**VALUE ENGINEERING STUDY**

***I-65 Widening from North of Cumberland  
Interchange to North of Munfordville  
Interchange***

**PROJECT ITEM NUMBERS: 3-12.00, 3-13.00, 3-14.00, 4-13.00, 4-14.00**

**Final Report December 13, 2010**

**ORIGINAL DESIGN**

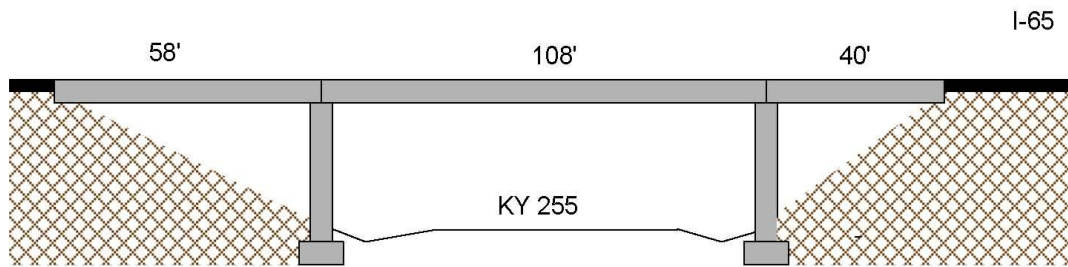
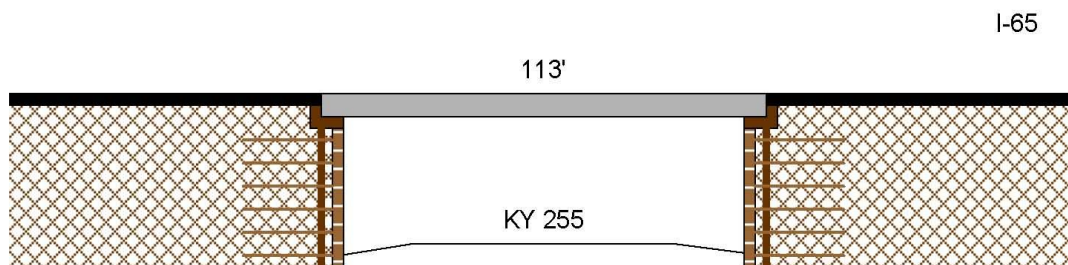
Option 1. Mechanically Stabilized Earth (MSE) Walls. The cost to replace the end spans with MSE abutments is estimated to be \$2,572,277.

Option 2. Modular Block Walls. The cost to replace the end spans with Modular Block abutments is estimated to be \$2,319,378.

Eliminating the end spans was done to improve economics without sacrificing functionality.

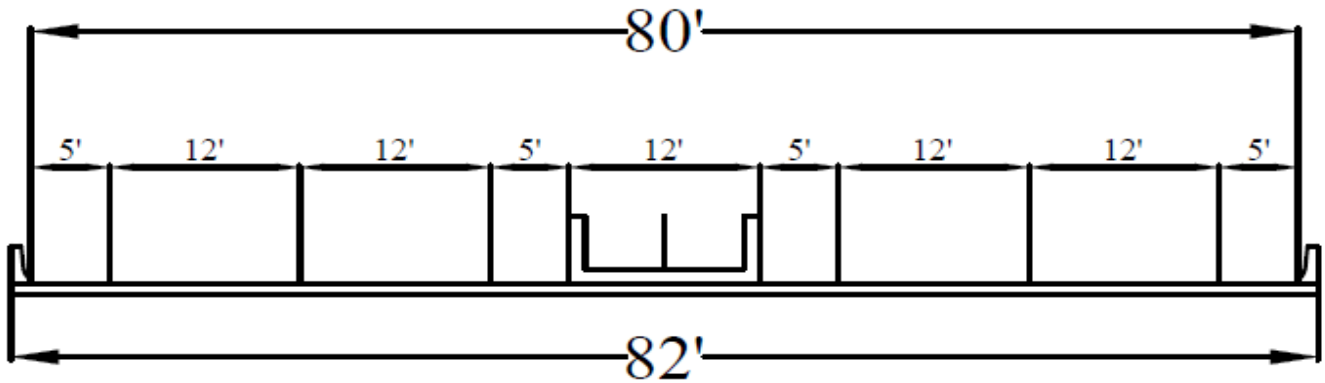
Cost savings are realized through narrowing the bridge deck width. The necessary bridge width is only 80', compared to 96', an initial savings of 17%. By moving the pedestrian traffic to the median on the bridge, the need for pedestrian fencing is eliminated. There is also a cost savings during the life cycle of the bridge by having a smaller deck area.

There are two travel lanes in each direction across the bridge. A single lane enters the bridge area from the west and then aligns next to the lane that turns from the southbound ramp. Pedestrian accommodations are combined into a single walkway on the center (median) of the bridge. Bike lanes remain to the right of the traffic.

#### Option 2: Diverging Diamond Interchange with Shortened Bridge

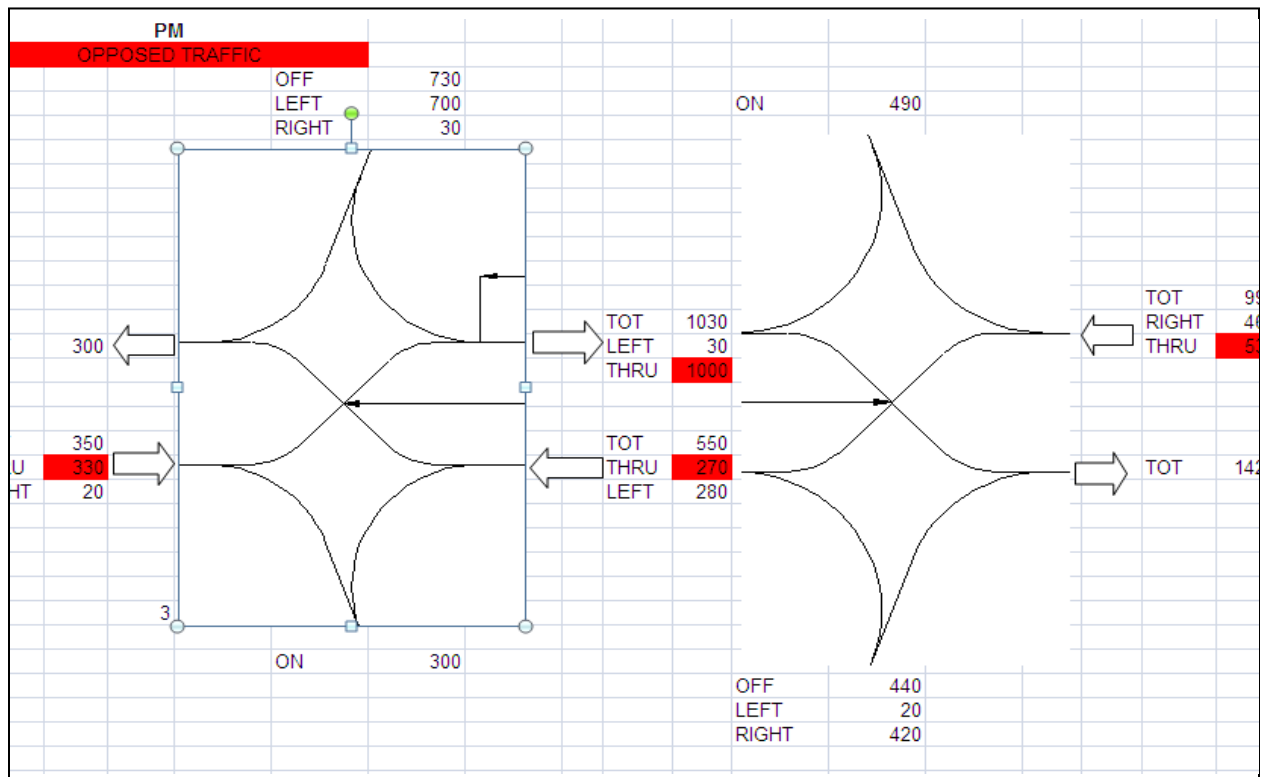
This option keeps the same interchange and lane configurations as in Option 1, but provides for a two-span bridge, rather than four. This reduces the total bridge length by 96' (298' versus 202'). This is achieved using either a Mechanically Stabilized Earth (MSE) Precast Prestressed Concrete (PPC) panels or a Modular Block Vertical Wall abutment.

Reduced Span Length with MSE or Modular Block Walls

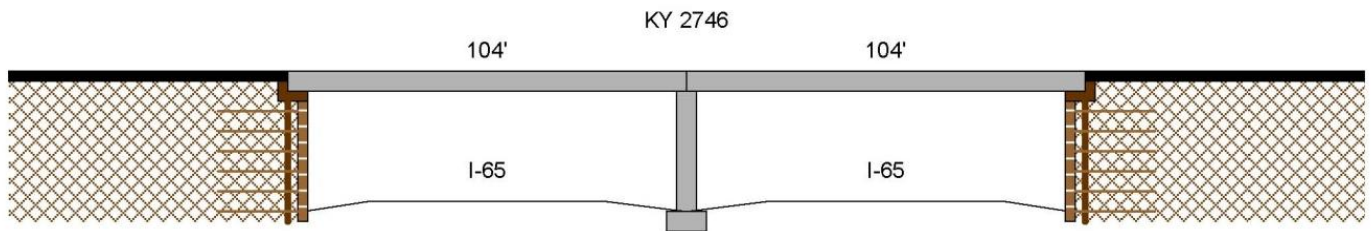
Option 1. Mechanically Stabilized Earth (MSE) Walls. The cost to replace the end spans with MSE abutments is estimated to be \$1,273,753.

Option 2. Modular Block Walls. The cost to replace the end spans with Modular Block abutments is estimated to be \$1,044,747.

Eliminating the end spans and replacing with MSE or Modular Block Wall abutments provides improved economy although for narrow structures, the economic impact is generally smaller than on the wider mainline bridges.
